APPLICATION NO.	FILING DATE	FIRST NAMED INVENTOR	ATTORNEY DOCKET NO.	CONFIRMATION NO.
09/484,421	01/18/2000	Martin Dubs	622/48561	9681

Office Action Summary	Application No. 09/484,421	Applicant(s) DUBS ET AL.	
	Examiner Gregg Cantelmo	Art Unit 1753

DETAILED ACTION

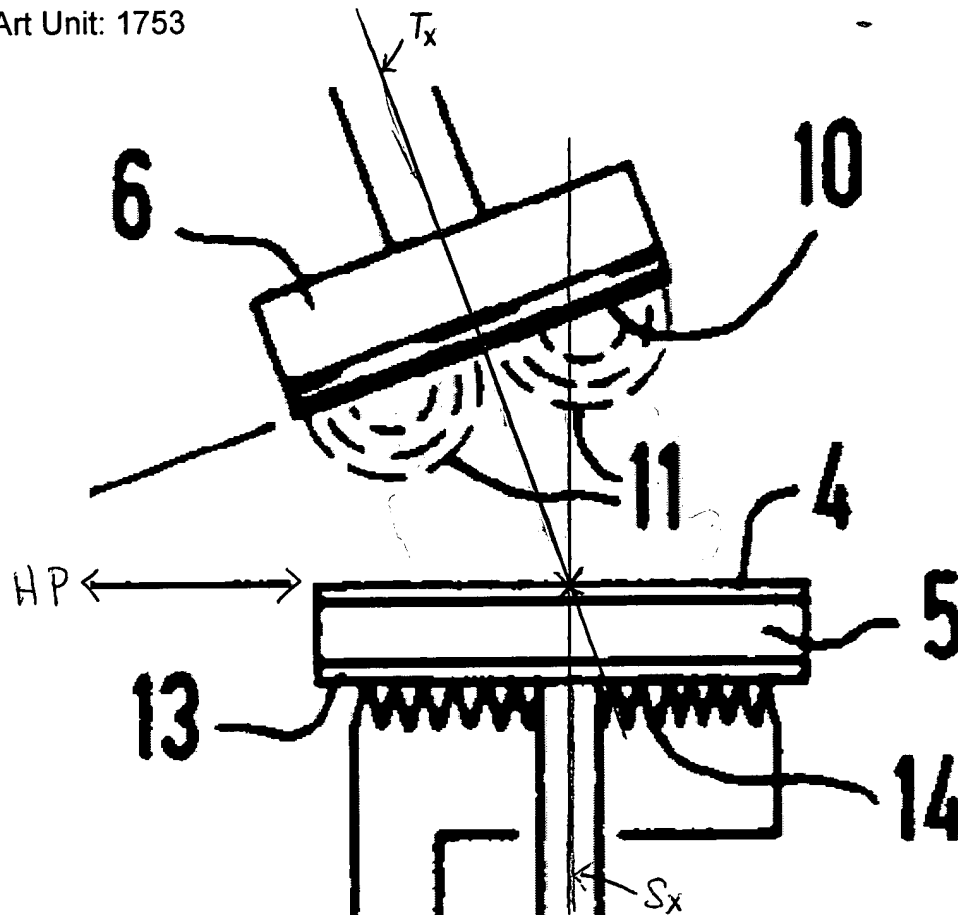
Fig. 1 discloses a sputtering chamber 3 comprising at least one sputtering source 6 with a new sputter surface 10 at least approximately symmetrical with respect to a first axis (Tx) (see drawing below for details), the axis being perpendicular to the sputter surface 10, substrate carrier 3 which is arranged to be driveably rotatable about a second axis (Sx), wherein the first and second axes are oblique with respect to one another and said sputtering source is a magnetron sputtering source with at least one toroidal magnetic field 11 around said first axis with symmetric field polarity considered in a cutting plane through said new sputter surface and containing said first axis (as applied to claim 35).

The first and second axes are virtual and infinite along the plane which defines each respective axis. Since the axes are oblique, they will intersect at some point (red X in marked up Fig. 1 above as applied to claim 37).

The first and second axes have a smallest mutual spacing situated on a surface of workpiece 18 (as applied to claim 42).

The substrate carrier 13 is located within chamber 3 at least approximately horizontally (HP in marked up Fig. 1 above as applied to claim 43).

The substrate carrier surface and new sputter surface bound a process space as shown in Fig. 1 (yellow highlight as applied to claim 57).

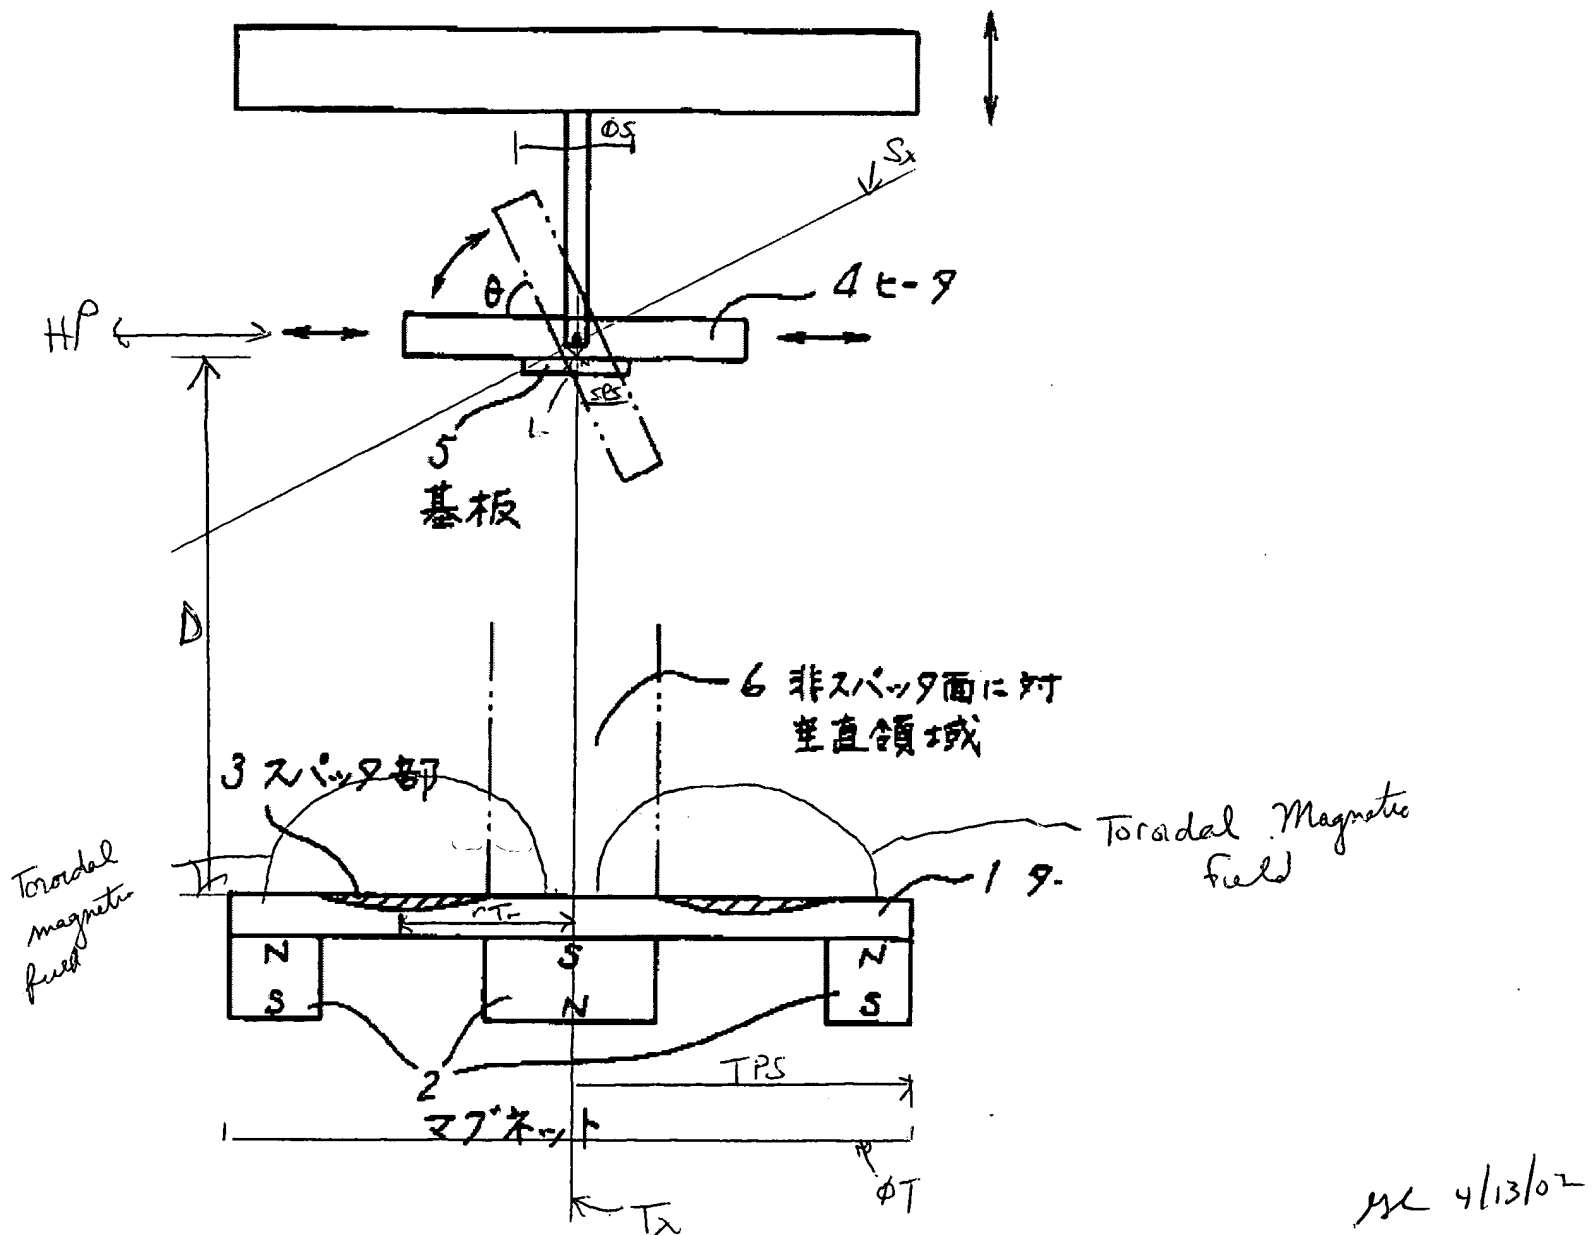
Fig. 1 discloses a sputtering system comprising an inherent sputtering chamber, at least one sputtering source 1 with a new sputter surface at least approximately symmetrical with respect to a first axis (Tx in marked-up drawing below), the axis being perpendicular to the sputter surface, substrate carrier 4 which is arranged about a second axis (Ts in the marked-up drawing below), wherein the first and second axes are oblique with respect to one another and said sputtering source is a magnetron sputtering source with at least one toroidal magnetic field. The field lines drawn in the marked up drawing below by Examiner on the basis that such field lines are inherent due to the configuration of the permanent magnet polarities and evident from the erosion profile 3 in the target surface. The magnetic field lines around said first axis with symmetric field polarity considered in a cutting plane through said new sputter surface and containing said first axis (as applied to claim 35).

When angled as taught by JP '568, the first and second axes, being oblique and infinite will intersect at least approximately (red X in the marked-up drawing as applied to claim 37).

The first and second axes have a smallest mutual spacing D (see marked up drawing below) situated at least approximately on a surface which is to be sputter coated of a substrate (see marked up figure as applied to claim 42).

As shown in Fig.1 rotation of the substrate holder is horizontal with respect to the bottom support surface for the rotating substrate holder (HP plane in drawing as applied to claim 43).

A projection of said new sputter surface onto a plane perpendicular to said first axis (denoted as TPS in the marked up diagram) is larger than a projection surface of the substrate (SPS) to be coated onto said plane (as applied to claim 44).

There is a circular erosion ditch 3 caused by the toroidal magnetic field generated by the permanent magnet relationship shown in Fig. 1, the radius (r_{Tr}) is about $1/3$ of the length D and is within the range of $1/4 \leq r_{Tr} \leq 2/3$ (as shown in the marked up drawing and applied to claim 46).

The target is substantially rotationally symmetrical about its central axis and has an inherent diameter (ϕT). The diameter of the target and length D are about the same (as applied to claim 47).

The substrate has a diameter (ϕ_s) and is much smaller than the length D. Therefore with a substrate diameter less than length D, the ratio of (ϕ_s)/D will be less than 1 (and less than 1.8 as applied to claim 49).

The locus of the smallest mutual spacing is on a plane defined by a surface of the substrate to be coated (see L in marked up figure as applied to claim 50).

The target and substrate face each other and bound a process space on the two sides thereof (yellow highlight Fig. 1 as applied to claim 57).

Fig. 12 PRIOR ART

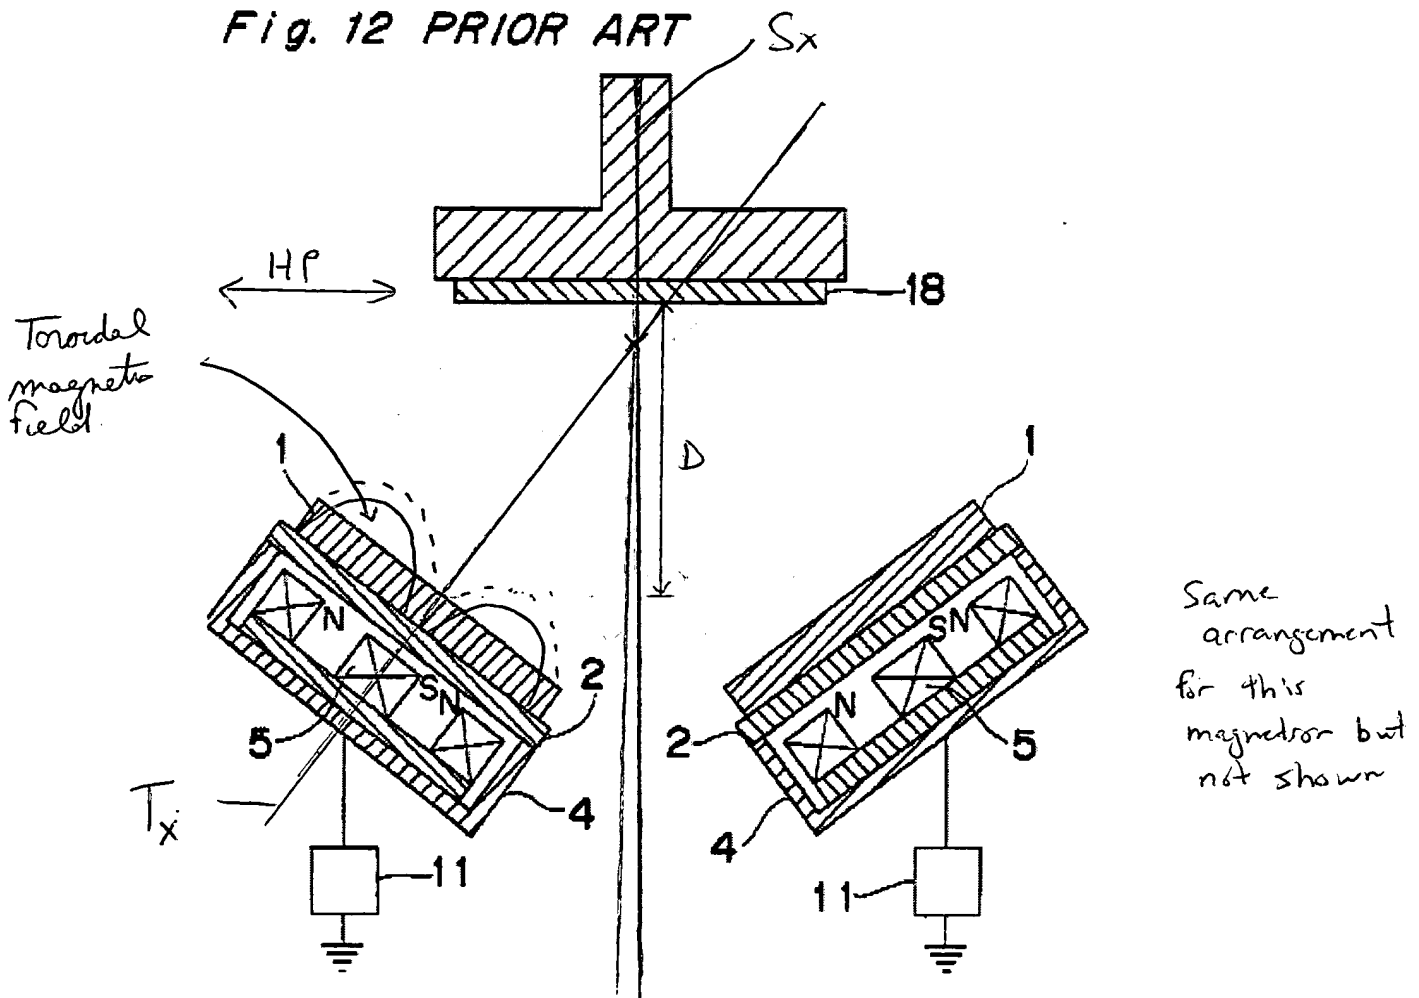
Fig. 12 shows a prior art configuration which read on the following claims: a sputtering chamber (not shown in Fig. 12 but inherent to a sputtering system, see Figs. 7 and 11 which show placement of sputtering equipment in a sputtering chamber

comprising at least one sputtering surface symmetrical with respect to a central axis (central axis Tx as marked up below) the axis perpendicular on said new sputtering surface, a substrate carrier (carrying substrate 18) having a second axis (Sx as marked up below) the two axes are oblique with respect to one another, and said sputtering source is a magnetron sputtering source wherein the magnet polarities are arranged such that they will generate a toroidal magnetic field around the first axis with symmetric field polarity considered in a cutting plane through the new sputter surface and containing said first axis. The field lines have been drawn in by the Examiner (dotted lines) given the location of each pole in the target, a toroidal field will result (see also col. 1, ll. 58-60 as applied to claim 35).

The first and second axes are virtual and infinite along the plane which defines each respective axis. Since the axes are oblique, they will intersect at some point (see red X in marked up Fig. 12 below as applied to claim 37).

The first and second axes have a smallest mutual D spacing situated on a surface of workpiece 18 (as applied to claim 42).

Two sputtering surfaces 1 having individual power sources 11 are provided in the system shown in Fig. 12 (as applied to claim 45).

The surface of the substrate 18 and its carrier and the surface of the sputter surfaces 1 bound a process space on two sides (yellow highlight Fig. 12 as applied to claim 57).

The prior art employs a method for coating workpiece 18 comprising: introducing workpiece 18 into the sputtering chamber, providing a sputtering source 1 with a sputtering surface and having a central axis which is oblique with respect to the axis of the substrate carrier, sputter coating the workpiece by the source where the source has a toroidal magnetic field with a symmetric field-polarity considered in a cutting plane through said sputter source which contains the normal axis (the toroidal magnetic field lines inherent to the magnetrons in Fig. 12 given the polarities of the electromagnets shown in the magnetrons as applied to claim 58).
